ADDENDUM B

ZOO NEW WEST ENTRANCE & OTTER EXHIBIT

Milwaukee County Zoo

February 24, 2106

D DRAIN TILE ARRANGEMENT
NOT TO SCALE

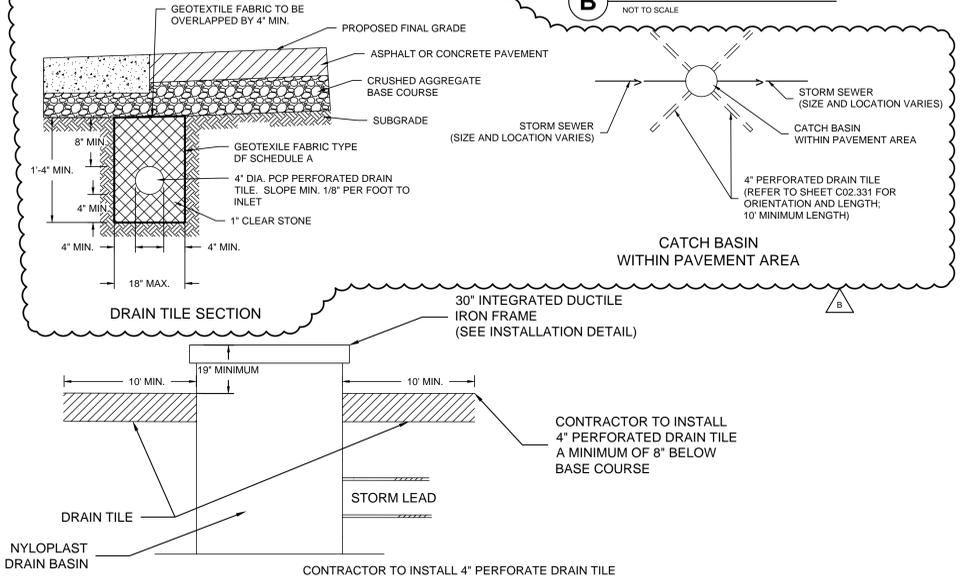
C	02	332A	Replacement of existing hydrant by water main connection deleted.	B	2/24/2016	Full Size		
	C	02	333	The replacement of the hydrant by the water main connection was eliminated.	B	2/24/2016	Full Size		
	C	02	333A	The replacement of the hydrant by the water main connection was eliminated.	B	2/24/2016	Full Size		
	C	02	341	Dewatering drain tile added to typical retaining wall section	B	2/24/2016	Full Size		
	C	02	342	Drain tile detail revised	B	2/24/2016	Full Size
